# Access Compliance Report

### (Curb Ramps)

| Intersection ID: 10029979 | Main Street: LAMPLIGHTER_PL | Cross Street: N/A       | Location: S            |
| ADA ID: C2BBED41F061      | Ramp Type: BlendTrans2      | Initial Pass/Fail: Fail | Overall Compliance: No |

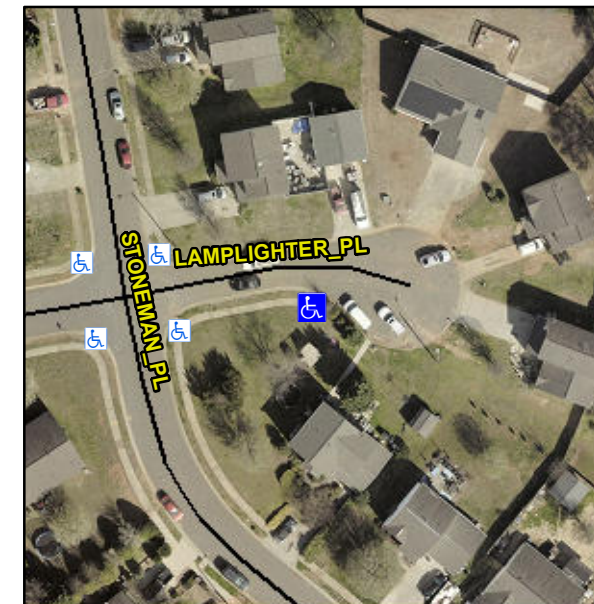
**Not Found, R304.5.1, R304.5.3**

| Compliance | Description           | Data | Compliance | Description                 | Data |
|------------|-----------------------|------|------------|-----------------------------|------|
| No         | Ramp Width (in)       | 41.0 | No         | BlendTrans XSlope (%)       | 5.2  |
|            |                       |      | No         | Curb Slope (%)              | 8.7  |

**Remove & Replace Curb Ramp With Two New Directional Ramps or Equivalent.**
